<b>Wulfsberg Electronics</b> <i>A Chelton Group Company</i>	
<b>APPROVALS</b>			
DRAWN	R. Durall	4-4-05	<b>TITLE:</b> <b>SERVICE BULLETIN WSB IDU-III-15</b> <b>(SOFTWARE APPLICATION VERSION 5.0B)</b>
CHECKED	D. Boston	4-4-05	
PRODUCT MANAGER	---	---	
ENGINEER	R. Durall	4-4-05	<b>SIZE</b> <b>A</b>
ISSUED	R. Talken	4-7-05	<b>CAGE CODE</b> <b>1B7G3</b>
			<b>DWG NO.</b> <b>150-045151</b>
			<b>REV</b> <b>E</b>
<b>Typed signatures indicate approval. Handwritten signature approval of this document is on file at Wulfsberg Electronics, Prescott, Arizona.</b>		<b>SCALE: NONE</b>	<b>DO NOT SCALE DRAWING</b>

## SERVICE BULLETIN

**BULLETIN NUMBER:** WSB IDU-III-15 Revision E

This modification updates the application software to 5.0B.

**Figure 12 Existing EFIS to Sfim PA85 Wiring Diagram**

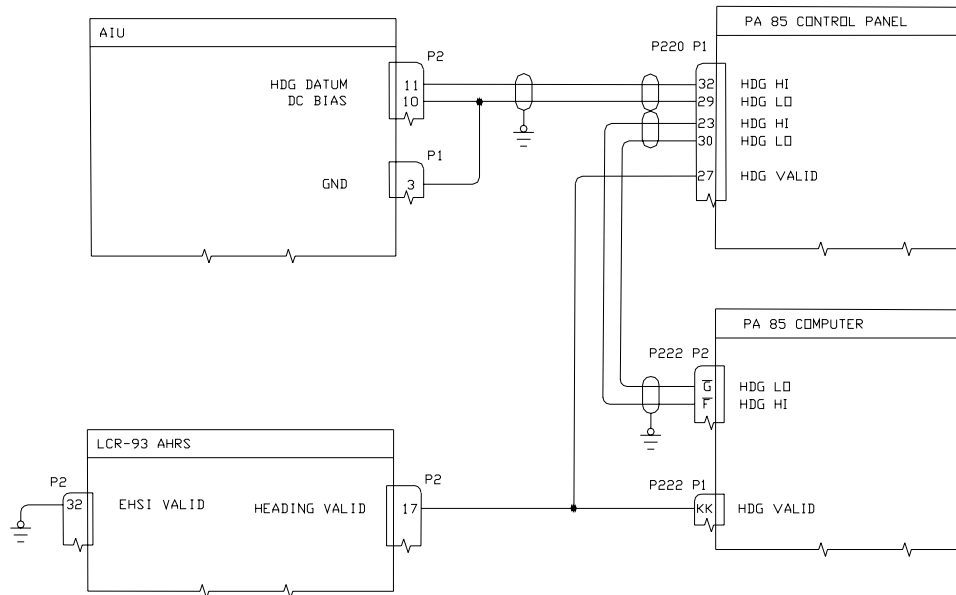
Verify the Autopilot Computer and Control Panel part numbers prior to modification. Refer to Figure 12 for existing interface diagrams during alteration.

**Figure 13 Sfim PA85 Wiring Diagram**

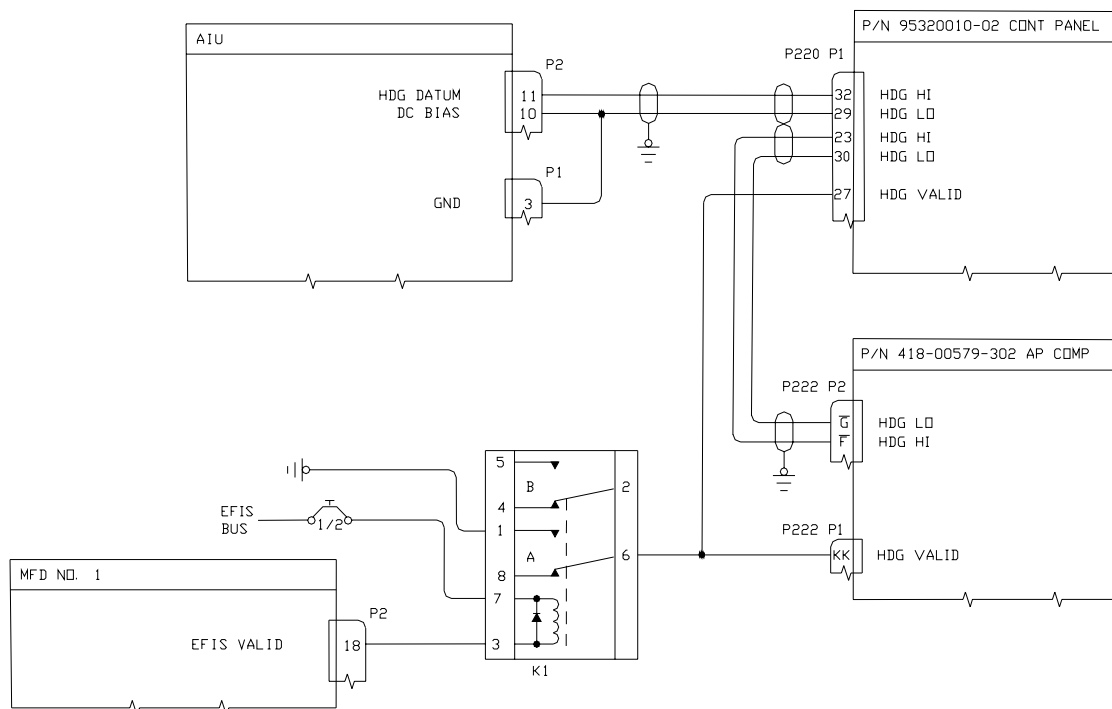
Rotorcraft with the EFIS interfaced to a Sfim PA-85 Autopilot under Chelton STC SR02209AK or SR02230AK must modify the wiring as follows using Figures 13 and 14.

The Sfim P/N 418-00579-302 Autopilot Computer with an American Automation Technologies P/N 95320010-02 Autopilot Control Panel is typically installed on a Eurocopter AS-350/355 rotorcraft.

1. Locate and install a DPDT relay in the aircraft. The relay shall be mounted using material, hardware, and techniques as outlined in FAA AC 43.13-1B and 2A or later revision.
2. Disconnect the wire from P2-Pin 17 of the Litef LCR-93 AHRS.
3. Extend this wire and connect to the wiper of the relay installed in Step 1.
4. Install a new wire from the EFIS MFD P2-Pin 18 to the low side of the relay coil.
5. Use or install a circuit breaker on the EFIS bus labeled "EFIS SWITCHING".
6. Install a new wire from the circuit breaker to the high side of the relay coil.
7. Install a new wire from the Normally-Open contact of the relay to airframe ground.
8. Using the IDU Limits program, set the EFIS Autopilot Valid Polarity to "Open = EFIS Valid" (See EFIS Installation Manual, Doc. 150-045264 or 150-045057, Chapter 5 for further details on programming the IDU Limits).

**Figure 14 Sfim Wiring Diagram**

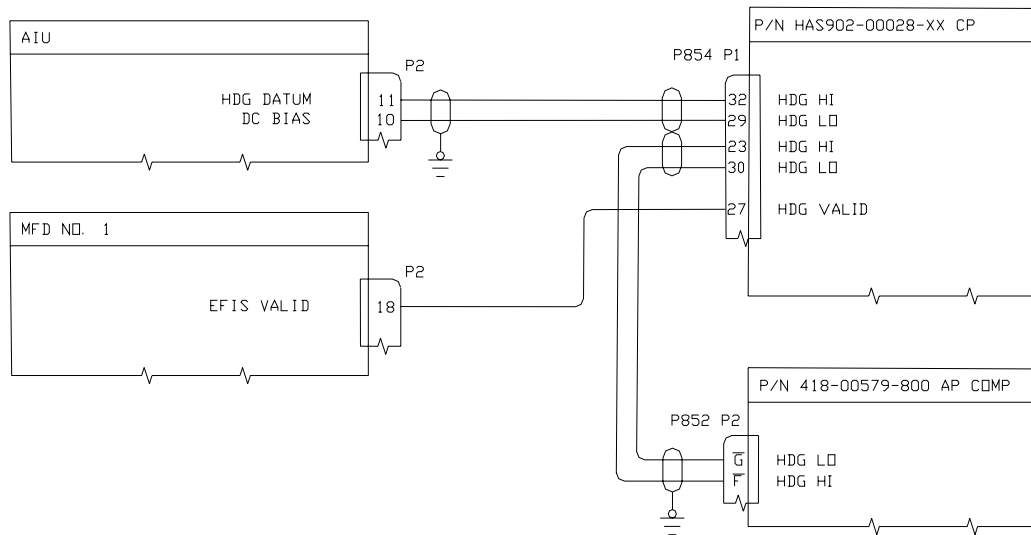
The Sfim P/N 418-00579-800 Autopilot Computer with a Sfim P/N HAS902-00028-XX Autopilot Control Panel are typically installed on Bell 407 rotorcraft.

1. Disconnect the wire from P2-Pin 17 of the Litef LCR-93 AHRS.
2. Extend this wire and connect to the EFIS MFD P2-Pin18.
3. Remove, cap and stow the wire from the PA85 Autopilot Computer P1-Pin KK.
4. Using the IDU Limits program, set the EFIS Autopilot Valid Polarity to “Gnd = EFIS Valid” (See EFIS Installation Manual, Doc. 150-045264 or 150-045057, Chapter 5 for further details on programming the IDU Limits).
